SUBJECT: NuScale Power, LLC Response to NRC Request for Additional Information No. 136 (eRAI No. 8933) on the NuScale Design Certification Application

eRAI No.: 8933

NRC Question No.: 03.07.02-17

Figure 1-10. Cracked RXB Y Acceleration Transfer Function Amplitude Comparison at Node 16287, RXM 1 at East Lug Support Location, for Soil Type 7.

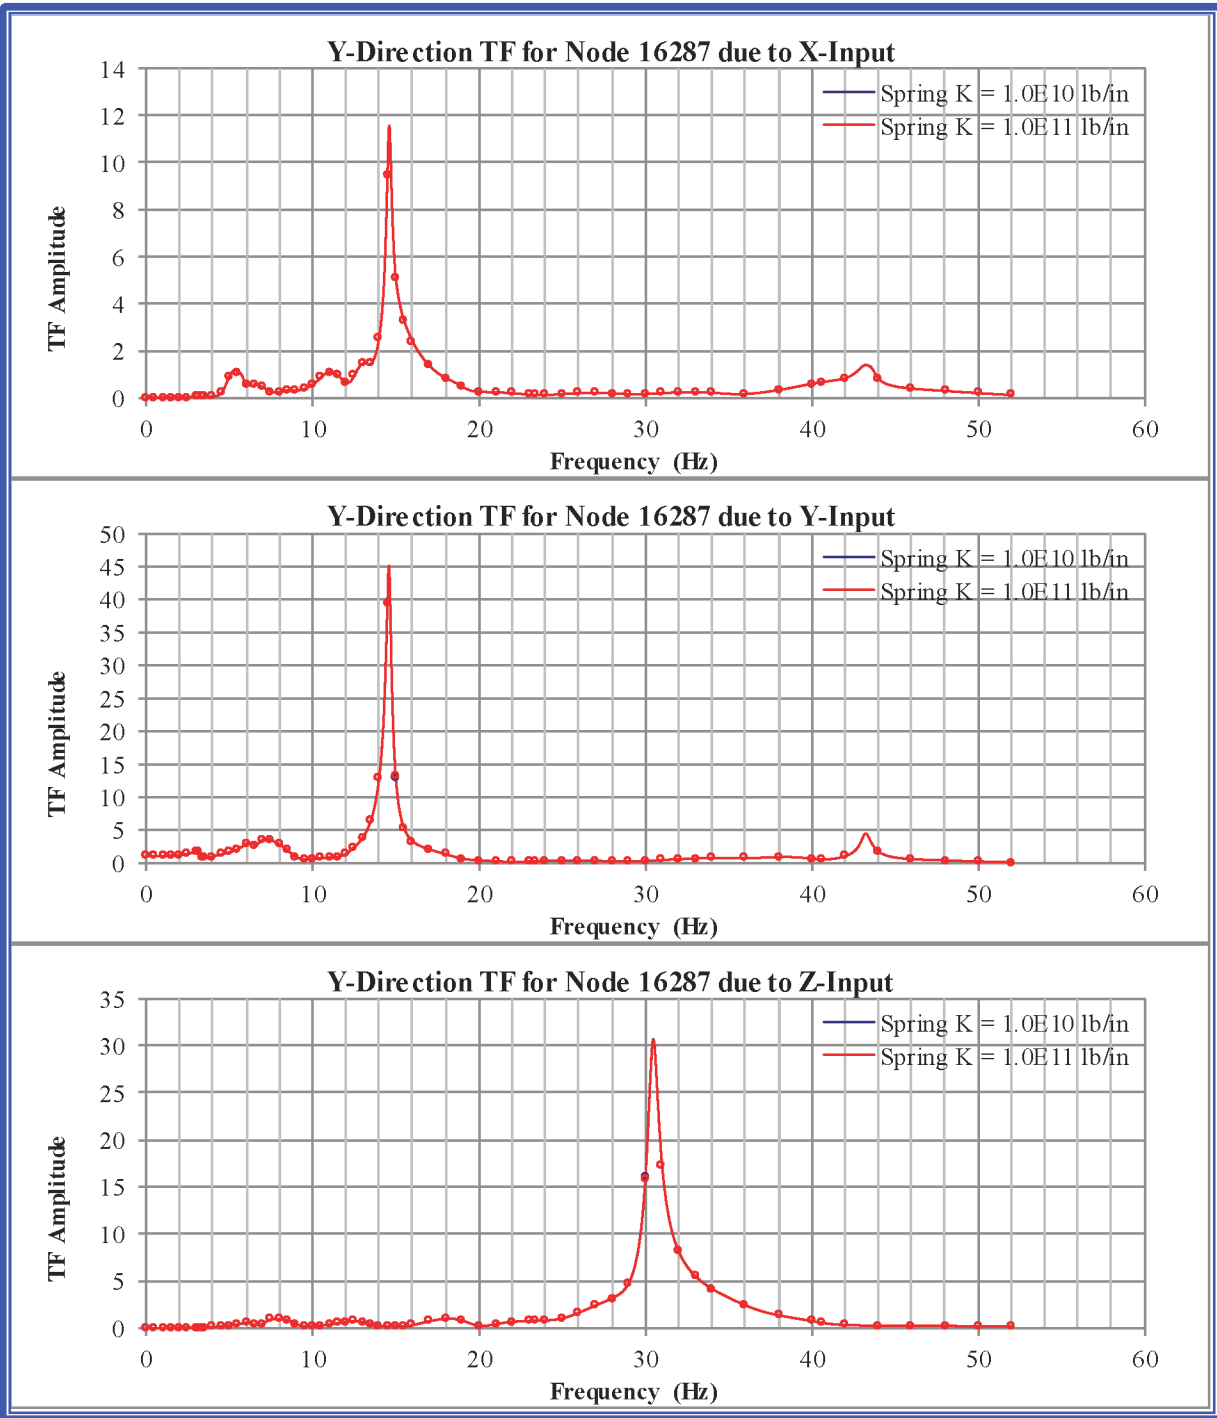
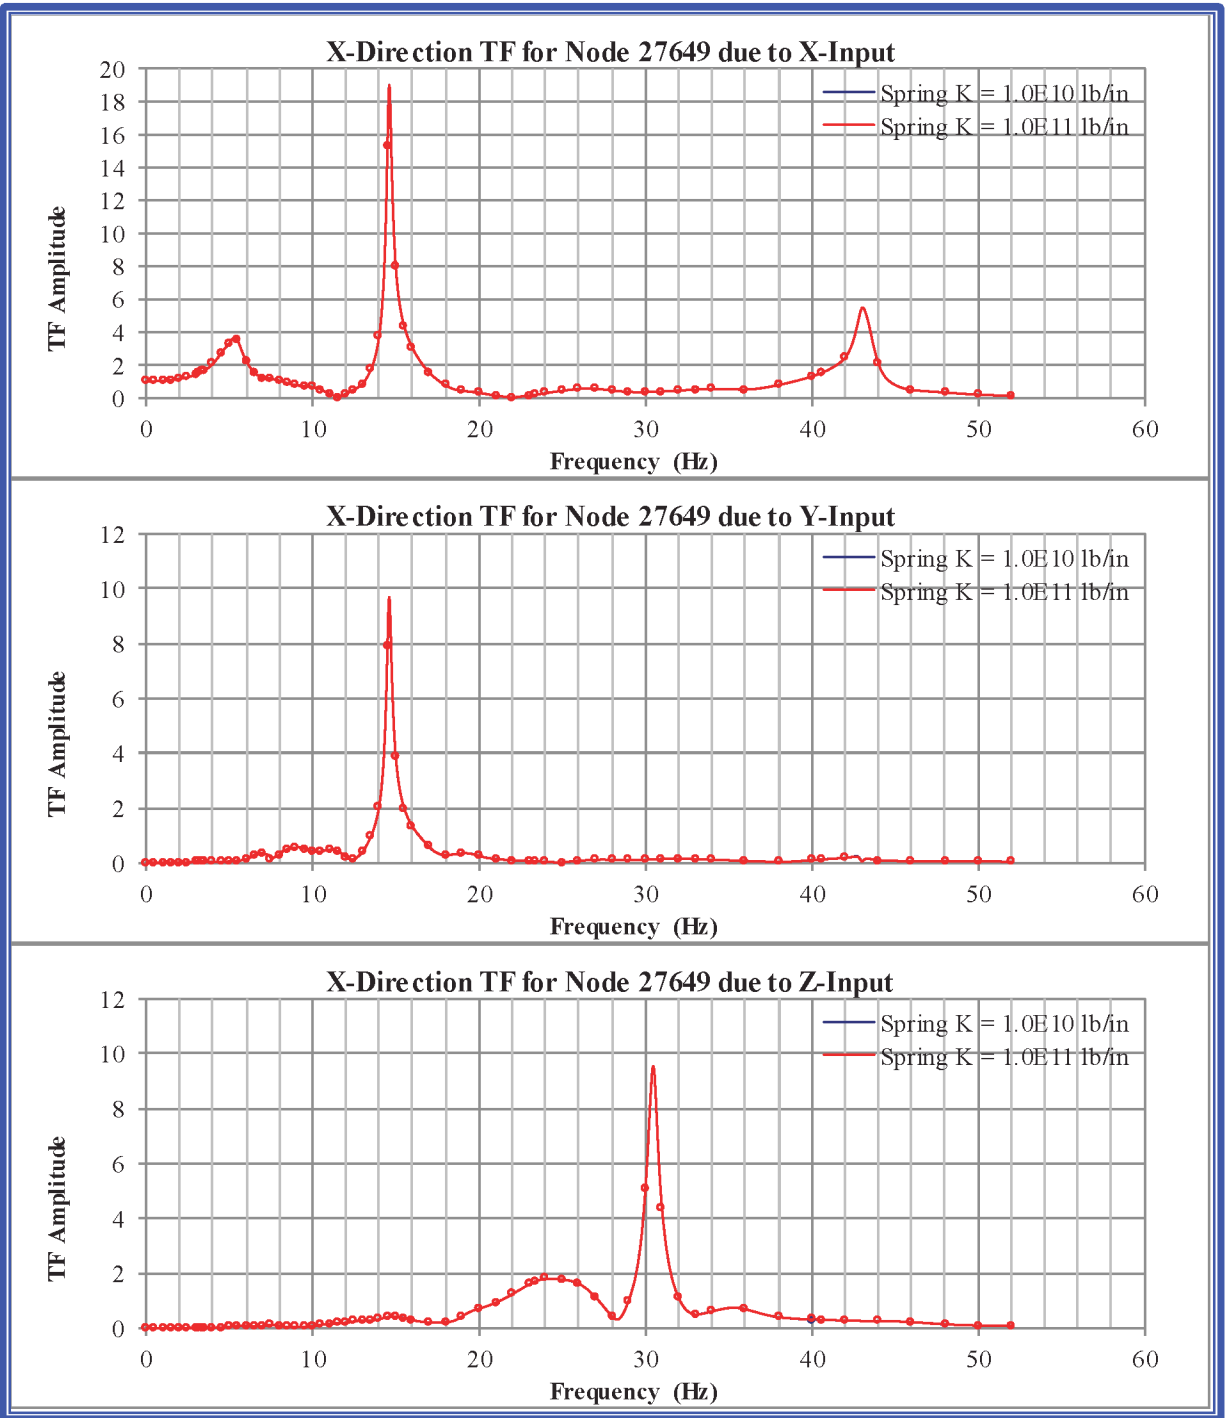
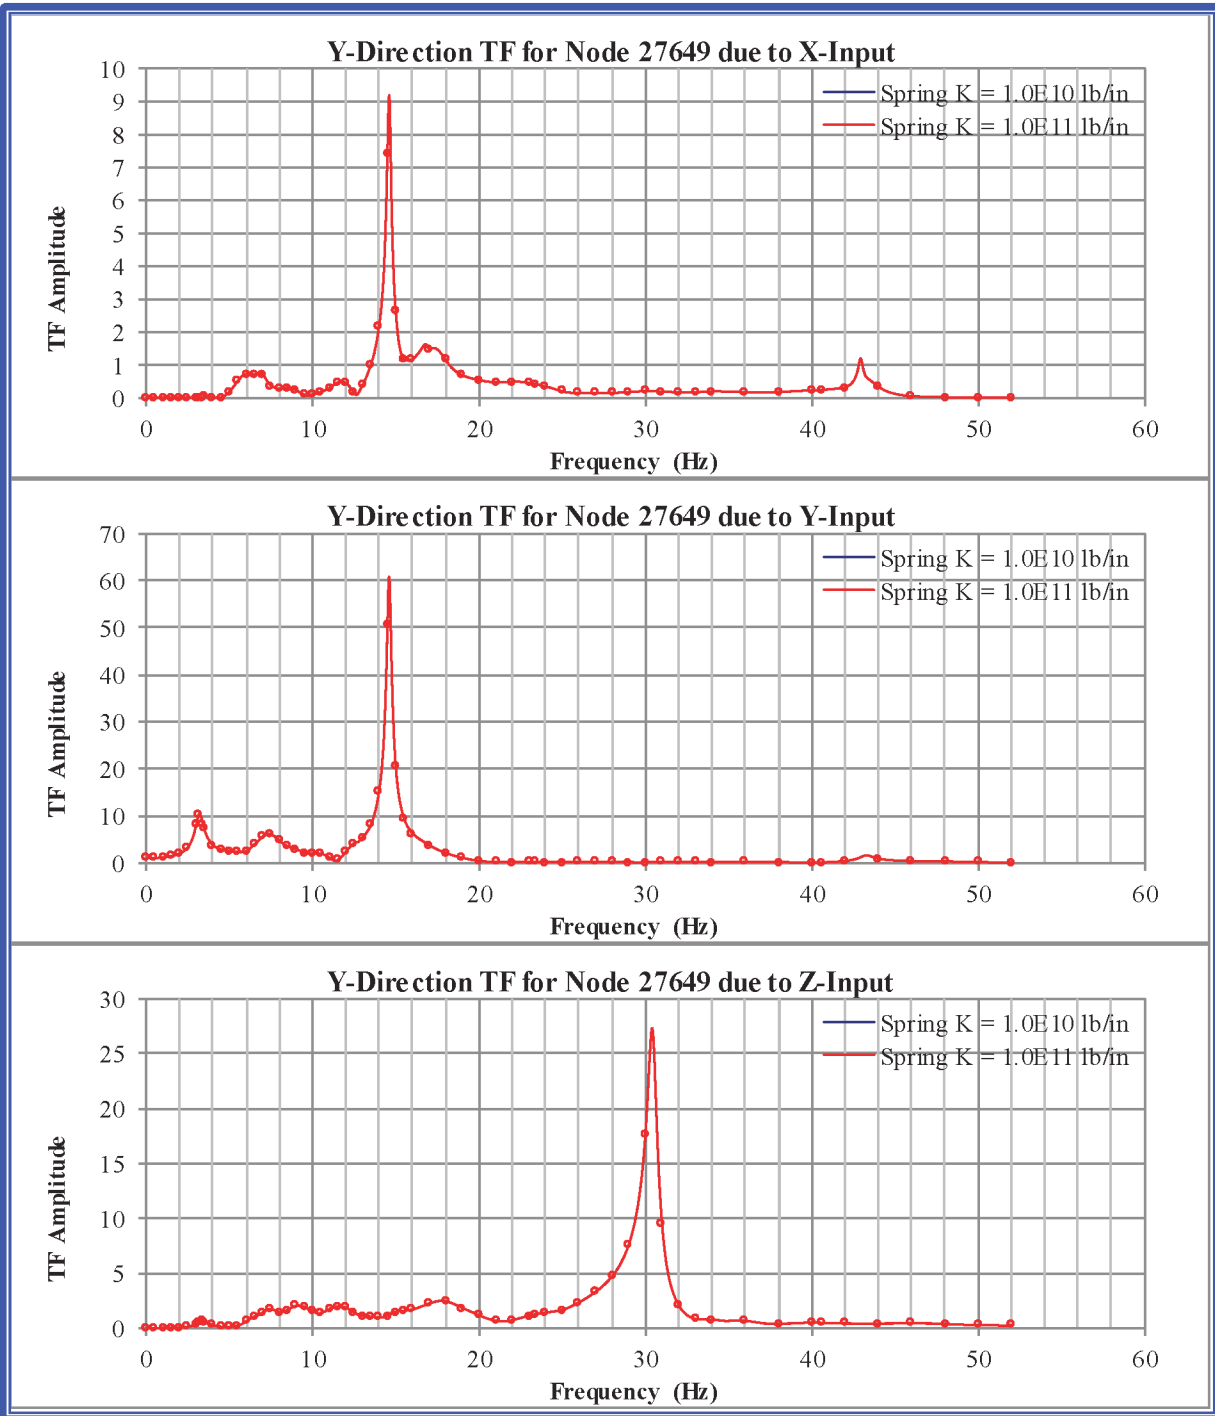
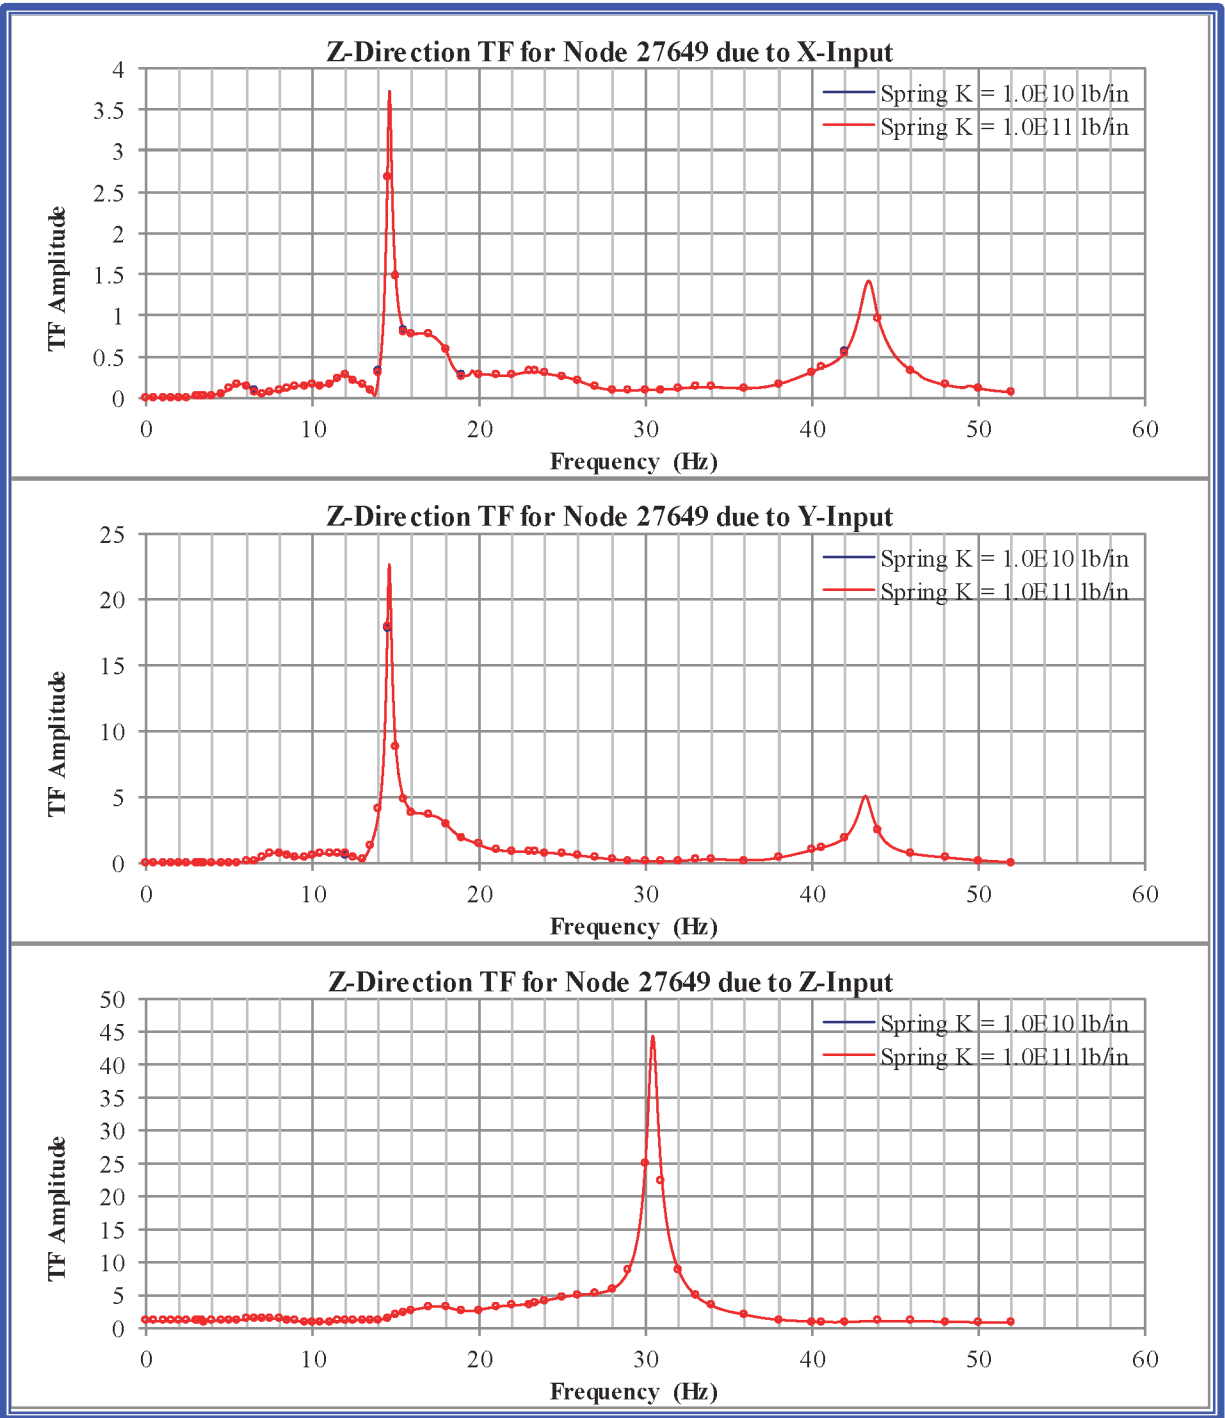
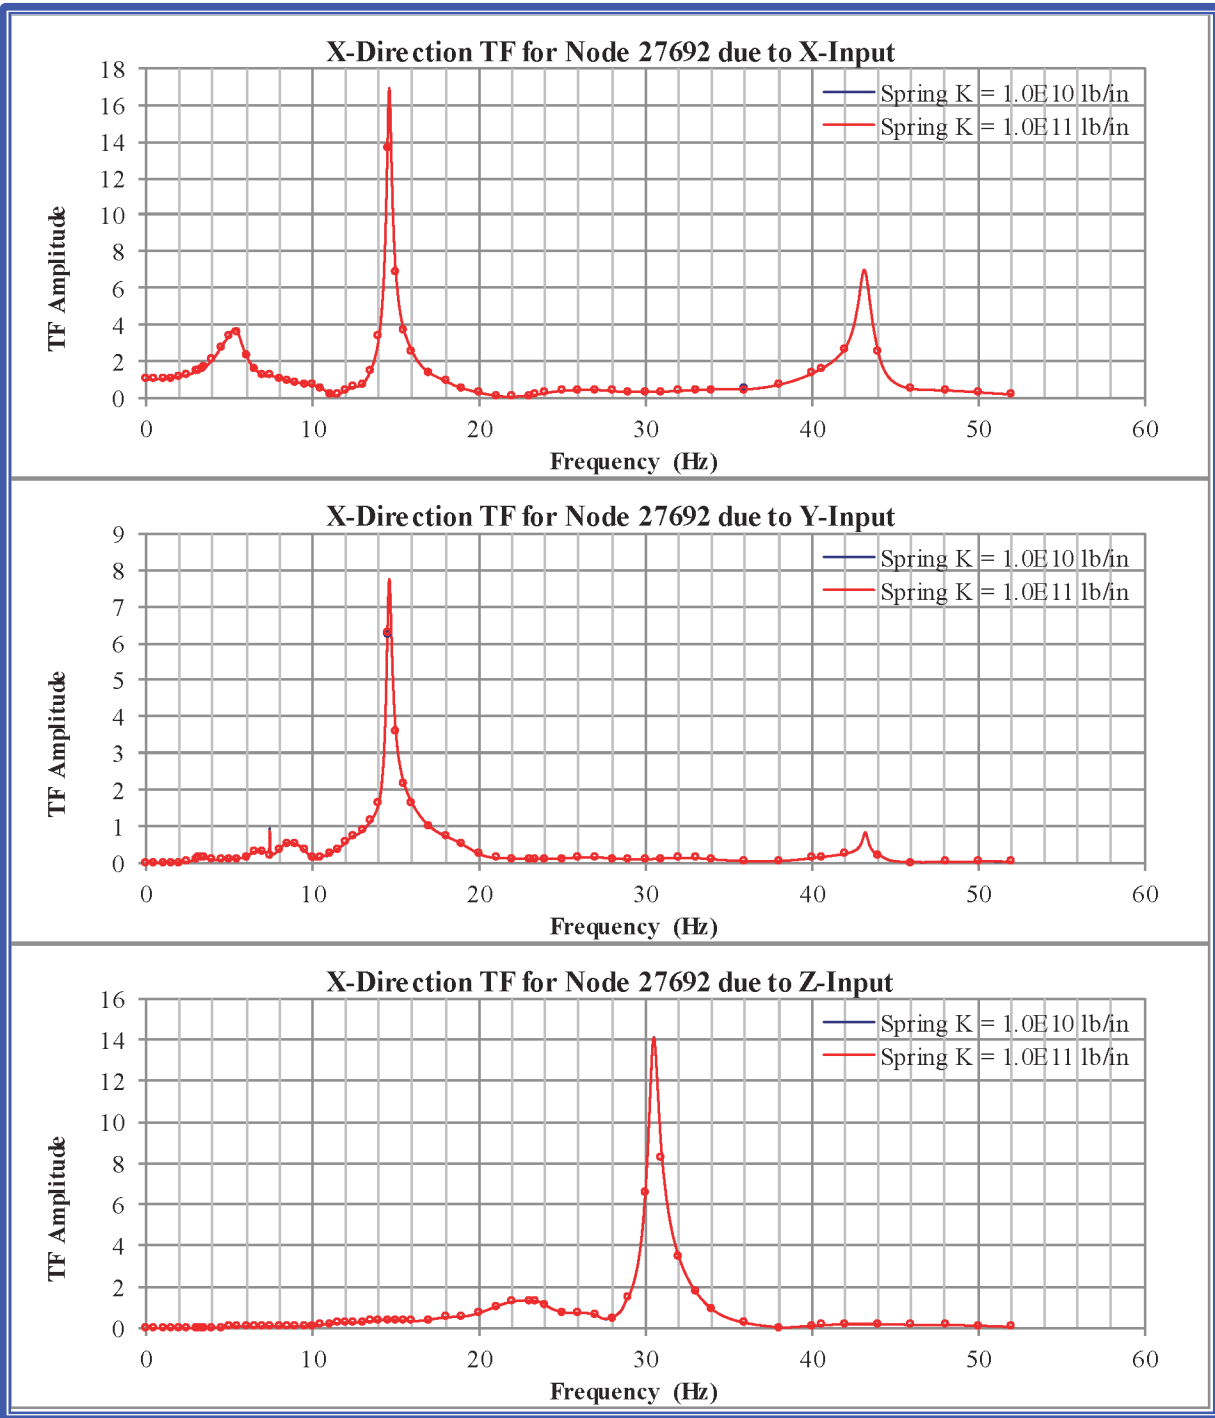
- b. On Page 3.7-25 of the FSAR, in the sixth paragraph, the applicant states, “The rigid springs have a zero length and have a stiffness value large enough to simulate rigid connection. The large stiffness used is arbitrarily chosen to be ten billion lbs per inch, or 1010 lbs/inch, in the three global directions.” For the spring to be modeled as a rigid spring, the value of its spring constant should be sufficiently larger than the stiffness of the structural element (basemat) to which it is attached. The applicant is requested to confirm the adequacy of the number (1010 lbs/inch) chosen for the spring constant by comparing it to the stiffness of the adjacent basemat element or through an appropriate sensitivity run using a number at least an order of magnitude different.

The locations of the nodes are shown in Figure 1-1 through Figure 1-4. The cracked concrete model with 7% concrete damping was used to generate these results. The TF comparisons are shown in Figure 1-5 through Figure 1-19. There are no discernible differences in the transfer functions between spring $K = 10^{10}$ lb/in and spring $K = 10^{11}$ lb/in.
